SPECIALIST COMMENTS RESPONSE – RANGITOOPUNI PROJECT – (COUNCIL REFERENCE BUN60449727)

Further to your recent instructions, we have reviewed the comments received from Auckland Council, Auckland Transport and NZTA on 18 September 2025 and have responded to the transport matters raised.

Figure 2: Sight line for Access 2 towards the west, showing sight line over 417 Old North Road

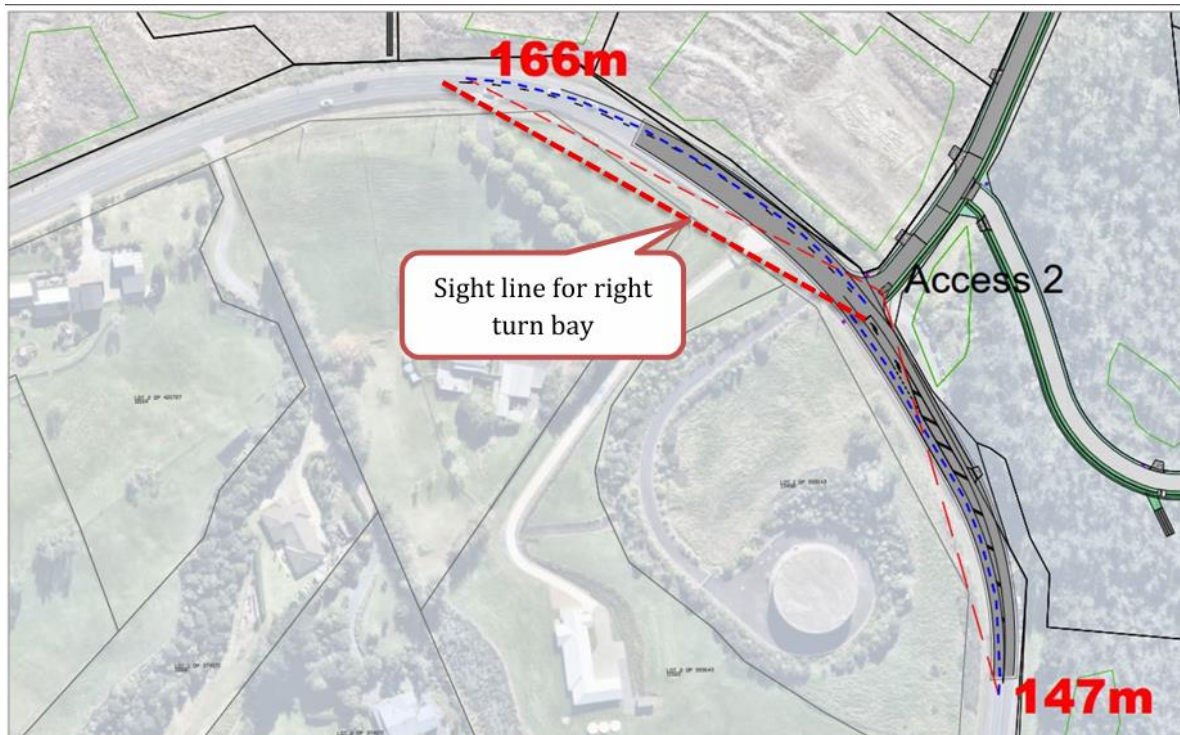
The western sightline for Access 2 crosses 417 Old North Road as shown in Commute Drawing SD A2, and my additional markups in the Figure below. This site is not owned by the applicant and therefore it is not able to apply land covenant over the property to ensure the sight line is protected. Further, as shown in Figure 3, the fencing for this property along with the horizontal and vertical alignment of Old North Road partially restricts the sight line. I am concerned about the potential safety effects due to:

In my opinion, these combined factors are point to an outcome that does not provide for safe access, contrary to Objective E27.2(4), and Policies E27.3(20) and (21).

To address the sight line shortfall, the exploration of relocating to the shared boundary between Lot 55 and Lot 57 is advised. I have shown the most efficient potential realignment of Browns Road to achieve this outcome in Figure 4, it is noted that this would require consideration of other effects of this change in layout. Access 3 could also be removed, as Lot 55 could gain access from the realigned Browns Road, however I acknowledge that Access 3 has sufficient sight lines in its proposed location and relocation of Access 3 is not necessary.

Figure 5: Sight line for Access 2 towards the west, from right turn bay

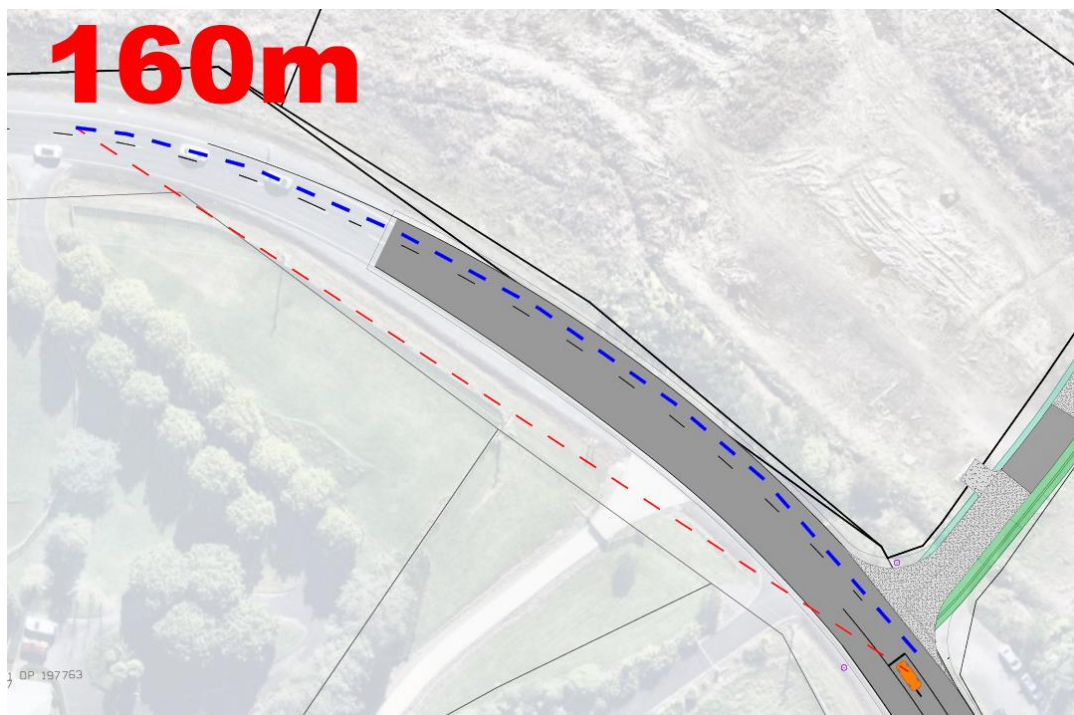
- This access has been operating for a number of years for users of the Forest (mountain biking / walking) without incident (even before its upgraded to a fully formed right turn bay)
- We generally agree with the comment regarding sight distance from right turn bay. We do however consider the diagram provided in the Council review is not quite accurate in that it both does not measure the sight distance from the right turn driver and does not measure the distance along the curve of the road as per Austroads. The accurate measure using CAD is provided in Figure 5 below.

As such we agree that sight lines from the right turn bay are limited (~158m) vs 166m required due to the curve and neighbouring properties. In this regard:

Figure 6: Potential alternative access to Lot 68 to remove sight distance infringement

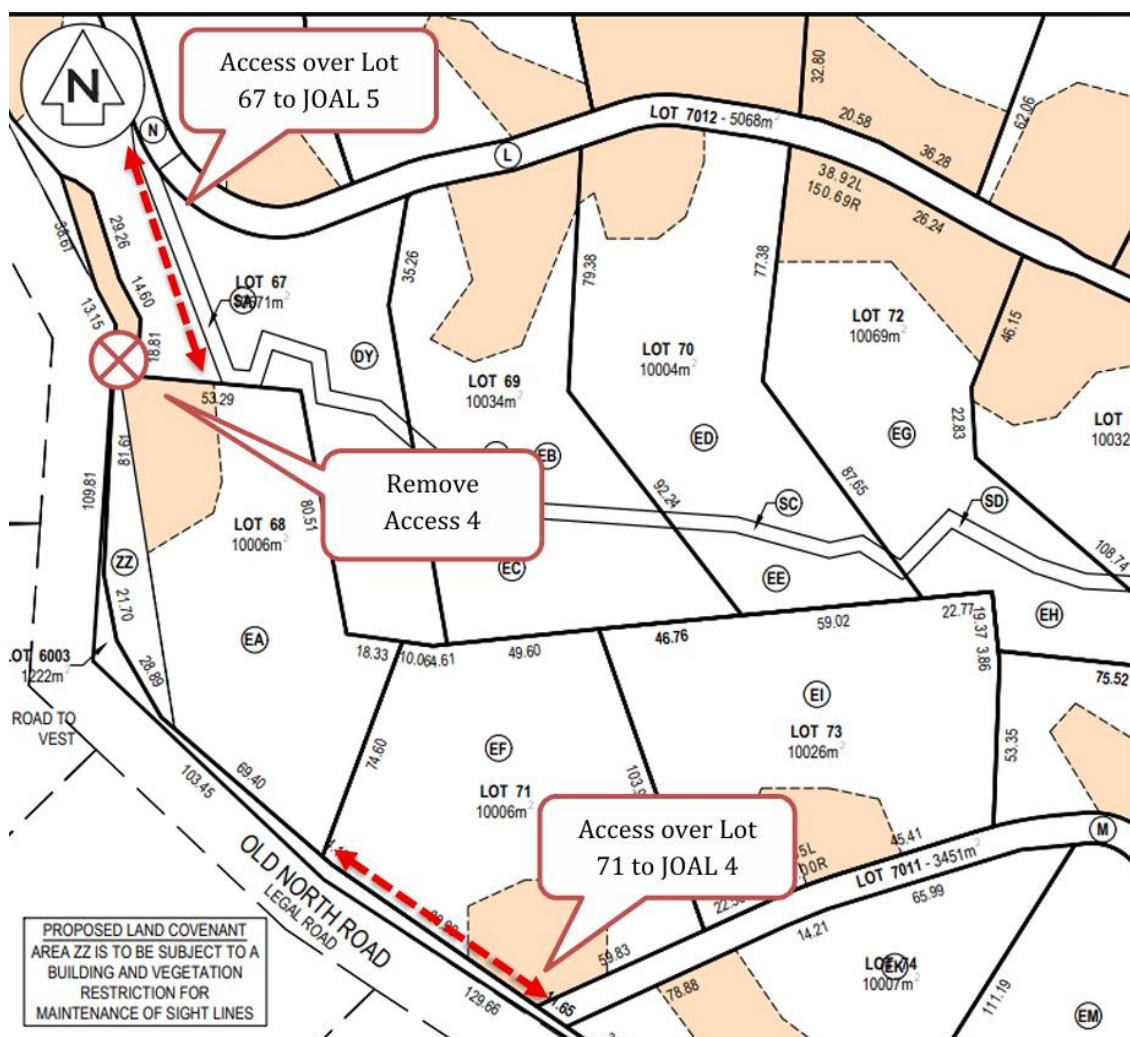
I am concerned about the western sightline for Access 4, which has a significant shortfall. This shortfall is more concerning when the longitudinal gradient of Old North Road is considered, as drivers on the western approach to Access 4 are travelling downhill and therefore will require longer braking distances (181m and 231m respectively for cars and trucks, assuming a 6% downhill gradient and a 76 km/hr operating speed). Access 4 (servicing Lot 68) should not be approved, to do so will create unacceptable risk. I recommend that access to this Lot should be from JOAL 5 (e.g. with right of way over Lot 67, along the edge of the pedestrian right of way) or JOAL 4 (e.g. with right of way over Lot 71) as potential options to explore, having limited effects on the overall layout of the proposed subdivision from a transport engineering perspective, noting other considerations would need to be taken into account.

Regardless, we do agree (which has been noted in the 19th August 2025 response) that there is a short fall in the western sight distance due to the gradient of Old North Road.

As per the 19th August response, although Access 4 does not technically meet the AUSTROADS recommended intersection sight distance, Access 4 is proposed to only serve one dwelling and hence is only anticipated to produce a single vehicle trip in the peak hour. It was thus deemed more appropriate to assess Access 4 sight distance against the RTS 6 guide (which assesses accesses rather than intersections) which recommends a sight distance of 105m for an operating speed of 80km/h which Access 4 does comply with.

Figure 7: Mitigations for Access 5

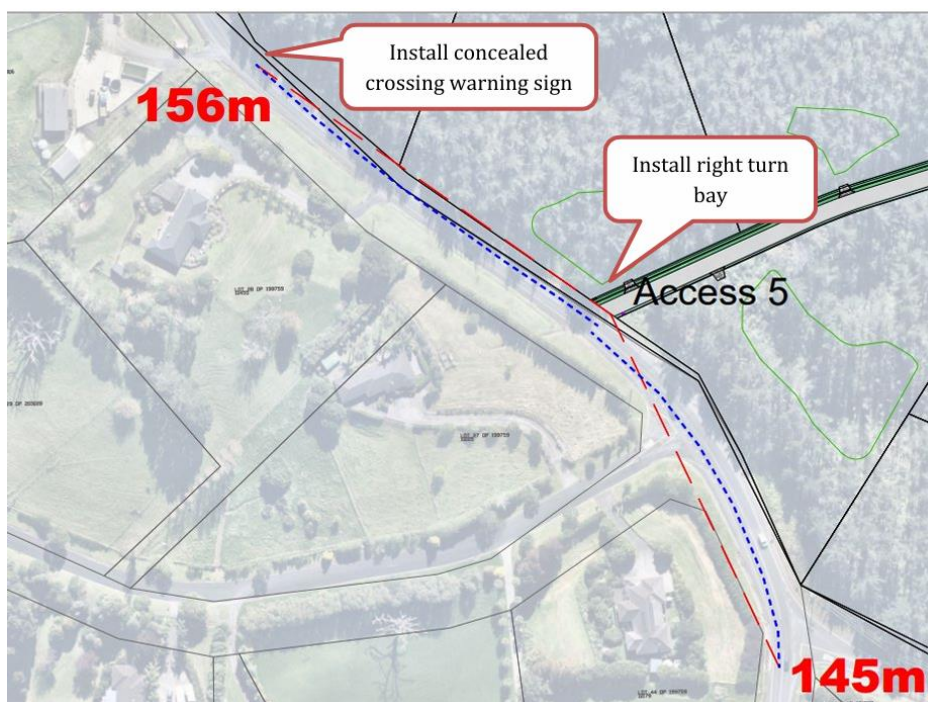
Similarly, the shortfall on the western approach to Access 5 is along a downhill gradient requiring 168m and 213m respectively for cars and trucks, assuming a 6% downhill gradient and a 72 km/hr operating speed). Access 5 (JOAL 4) will serve 9 Lots, and therefore will generate a reasonable number of vehicle movements, particularly during peak hours. I have considered whether an alternative location for the access could improve increase the available sightline but have not identified any suitable location.

If the Expert Panel chooses to approve Access 5 in its current location, to address the sight line and ensure turning traffic does not conflict with through movements then I strongly recommend that a right turn bay is provided on Old North Road, per the design for Access 1 and Access 3, and that advanced warning signage alerting drivers to a concealed crossing is installed on the western approach, as indicated in Figure 7.

Noted and agree that Access 5 does not meet AUSTROAD sight distance requirements to the east. As per Item G-K of the Commute Specialist Response Dated 19th August 2025, Access 5 is only proposed to serve 9 dwellings and therefore we consider Access 5 is to be low volume and find the RTS 6 Guide regarding sight distances to be more appropriate.

The RTS 6 Guide recommends a sight distance of 110m for an operating speed of 80km/h, the provided sight distance easily complies with the above recommendation and is considered to be acceptable.

Figure 8: Mitigations for Access 5 (fully Austroads to the west)

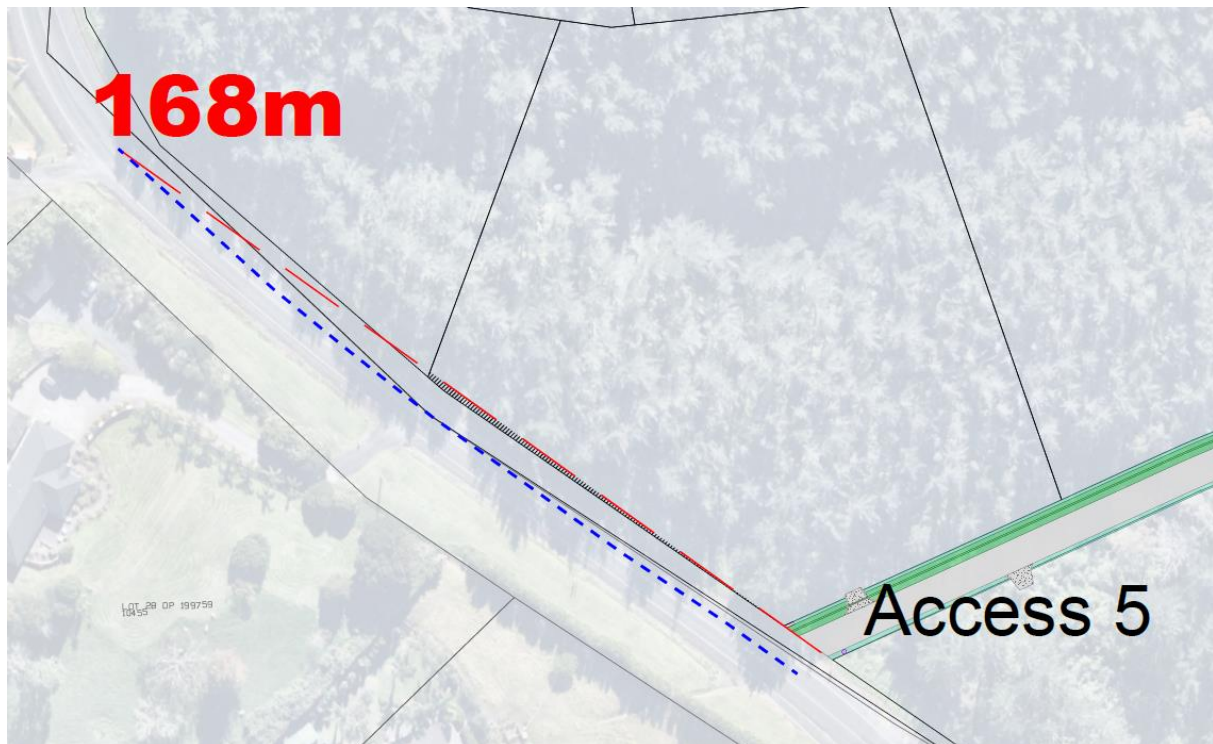
It is also noted that the 156m sight distance to the west is based on the existing arrangement including the existing trees. When these are removed, a covenant could easily be provided on the adjacent lots (similar to Access 1) to provide the 168m sight distance to the west as suggest by the Council review to fully achieve the Austroads requirements. This is shown in Figure 8 below.

Figure 10: recommended amendments to Old North Road/Access 1

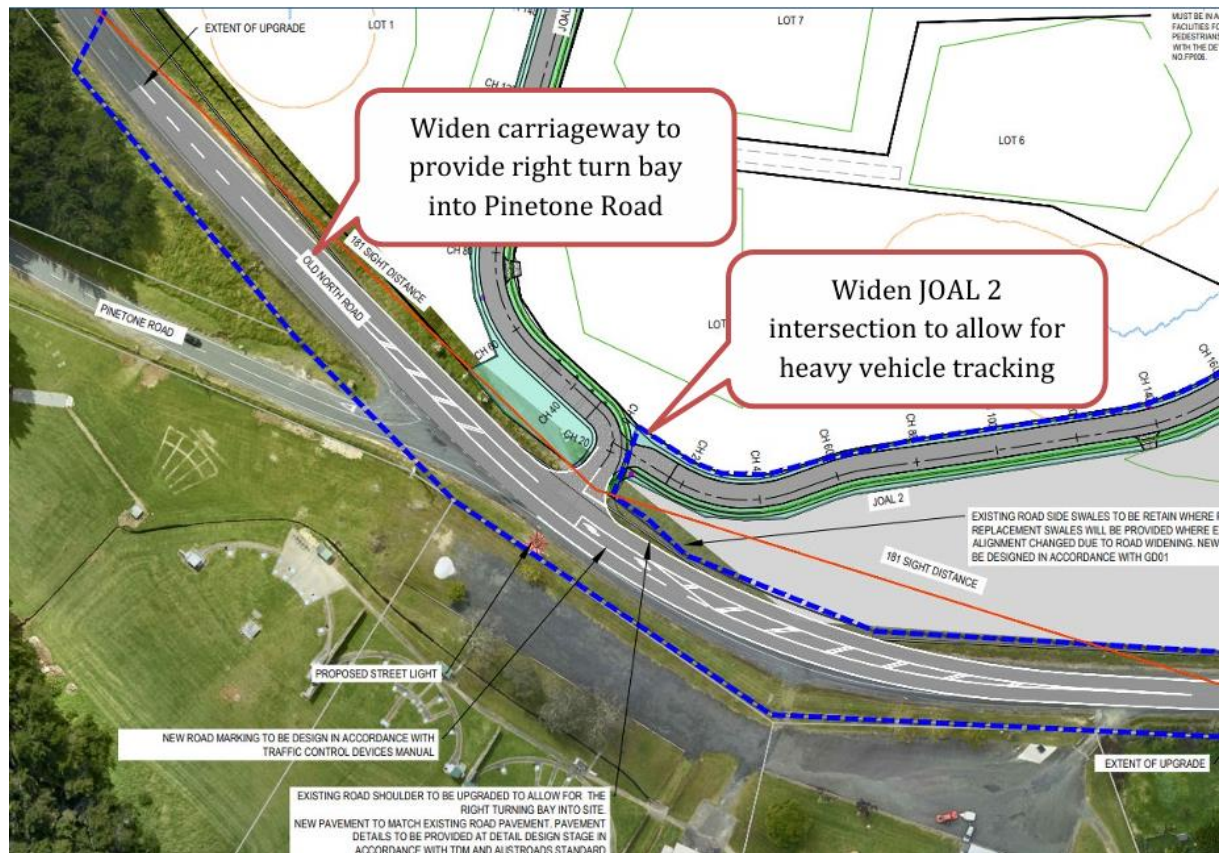
Regarding the interaction with Pinetone Road, I remain concerned about the interaction between Pinetone Road and Access 1. To reduce safety risks at this location, I recommend that the applicant provide a right turn bay for Pinetone Road.

Regarding the JOAL 2 tie in with JOAL 1, I am not convinced by Commute's assessment of the potential for queuing off the site. I note that JOAL 1 serves 33 lots, and as such will operate similar to a low volume load public road in terms of traffic volumes. Auckland Transport's Urban and Rural Road design Guide Table 2 requires Local to Arterial Road intersections to accommodate an 8.3m truck to remain within the marked lane when tracking through the intersection. 8m truck tracking provided in the ITA, and reproduced in Figure 9 below, shows an outbound truck needing to occupy the full carriageway of JOAL 1 and JOAL 2. A truck driver undertaking this manoeuvre would not be able to see any car turning right from Old North Road into the site. Further, for an inbound truck movement, an outbound car would need to wait a significant distance within the site to allow the truck to pass. Compounding this matter is the potential for gates to be erected.

- *JOAL 2 is widened at the intersection with JOAL 1, to ensure an 8m truck can manoeuvre through the intersection without tracking across the opposing vehicle lane*
- *Any gates on JOALs are set back at least 12m from the road boundary, to provide stacking space for one truck or two cars.*

I have shown these recommendations in Figure 10.

- Pinetone Road is a low volume, dead end, cul-de-sac road (in the order of 15 dwellings), clear sight lines are provided between each intersection, and the proposed Access 1 is located well outside the vehicle access restriction area of 10m.
- Most of the traffic entering Pinetone Road will be turning left (from Auckland).
- As per the Commute Specialist Response dated 18th August 2025, SIDRA intersection modelling of the Access 1 intersection was undertaken in both the AM and PM peaks. Modelling highlighted that queuing on all approaches would not exceed an average of 0.5 vehicles across both the AM and PM peak periods
- We agree with the comment regarding the 8m truck and as such the engineering plans have been altered to ensure an 8m truck and 85th % vehicle can use the access simultaneously.
- As per latest plans, no gates are proposed on the JOALs.

Figure 11: LOT 1 & 2: TRACK NETWORK, (Source: Rangitootupuni Masterplan)

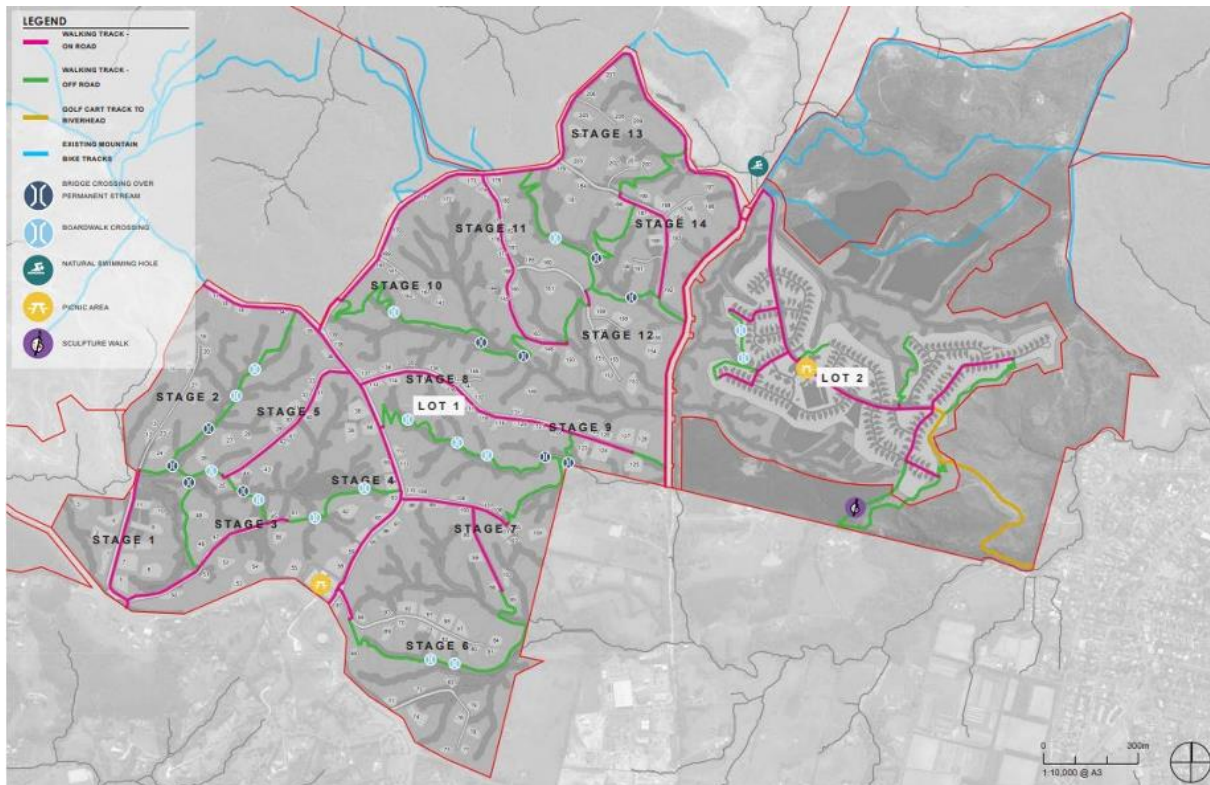
The Masterplan and Landscape Concept Plan shows multiple pedestrian paths through the site (refer to Figure 11), easements are shown on the Lot plans, although formation of the connections is not shown in the Engineering Drawings. If these connections are not provided this will significantly limit walking and cycling accessibility, resulting in increased car dependency.

I therefore recommend that, if the application is approved, a condition of consent is applied that requires the consent holder to form these paths to Council's satisfaction.

Furthermore, given the lack of footpath facilities within JOALs, I recommend that traffic calming is provided at not more than 50m spacing along all JOALs.

Noted and agreed that pedestrian footpaths should be confirmed and added to engineering plans; however, the footpath connections will be private but will not restrict access to the public.

We do not agree that the paths will need to be formed to Council requirements as there is no requirement for this as they will be privately managed. Refer to planning response for additional information.

Traffic calming devices are not required on a private rural accessways. They carry low vehicle volumes, operate at naturally reduced speeds due to their rural design and context, and are not part of the public roading network. Introducing engineered calming measures in this environment would provide no material safety benefit, and in some cases could impede services or emergency vehicle access.

Figure 13: Proposed Access 1 Layout with visibility splays highlighted

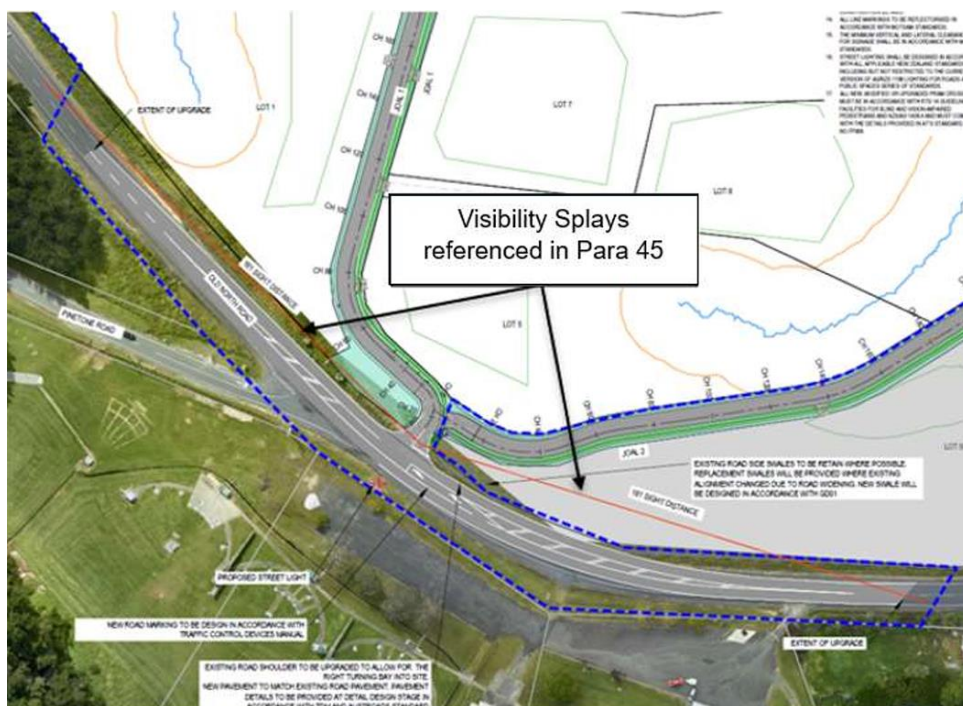
44. The existing site access on Old North Road will be upgraded with a right-turn bay and flush median. However, the design does not fully account for nearby Pinetone Road. It is recommended that right-turn movements to and from Pinetone Road be better integrated into the design. Final details can be resolved during the EA process, and sufficient land appears to be available for any required widening.
45. Visibility splays are generally acceptable, with a land covenant proposed to maintain sightlines to the east. To the west, vegetation and embankments may need to be removed or modified.

46. Vehicle tracking shows a 10.3m truck slightly encroaching into the right-turn bay, which will need to be addressed at the EPA stage. The access splits into two JOALs, and while queuing is expected to be minimal, the design should ensure vehicles can enter without being blocked by outbound queues.
47. Gates are proposed for both JOALs and will be set back at least 6m, forming a T-shaped turning head to allow vehicles to turn around safely if needed.
48. Access 1 is within 10m of Pinetone Road, triggering vehicle access restrictions under AUP Rules E27.6.4.1(2) and (3). While this requires assessment as a restricted discretionary activity, there are no existing safety concerns, visibility is adequate, and the access is not

Item 44-46: Refer to Section 1.3 regarding revised tracking for Access 1 and a right turn bay for Pinetone Road. Also see revised engineering drawings.

Figure 14: Forestry Road / Deacon Road Intersection

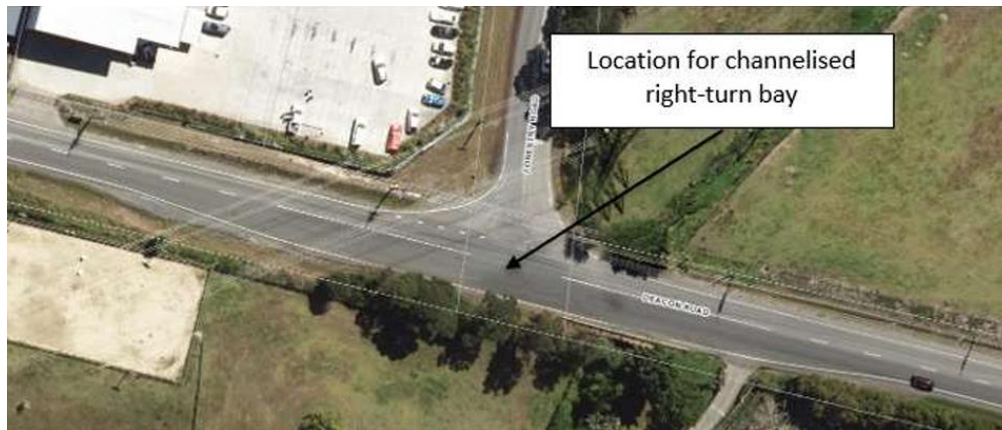
57. The intersection of Deacon Road and Forestry Road will serve as a key access point for the retirement village and some Countryside Living dwellings. Currently, there is partial lane widening that allows westbound vehicles to pass others turning right into Forestry Road. However, the proposed development will significantly increase right-turning traffic—around 90 vehicles per hour during the PM peak.
58. Although a specific assessment has not been provided, AustRoads guidelines indicate that a channelised right-turn bay is warranted based on traffic volumes. For safety and operational efficiency, it is recommended that a dedicated right-turn bay be implemented as part of the development (refer to Figure 14).

A right turn bay is now proposed into Forestry Road which will require minor widening to Deacon Road. Detailed design of the right turn bay will be left to EPA stage as all works will occur within road reserve. See latest engineering plan.
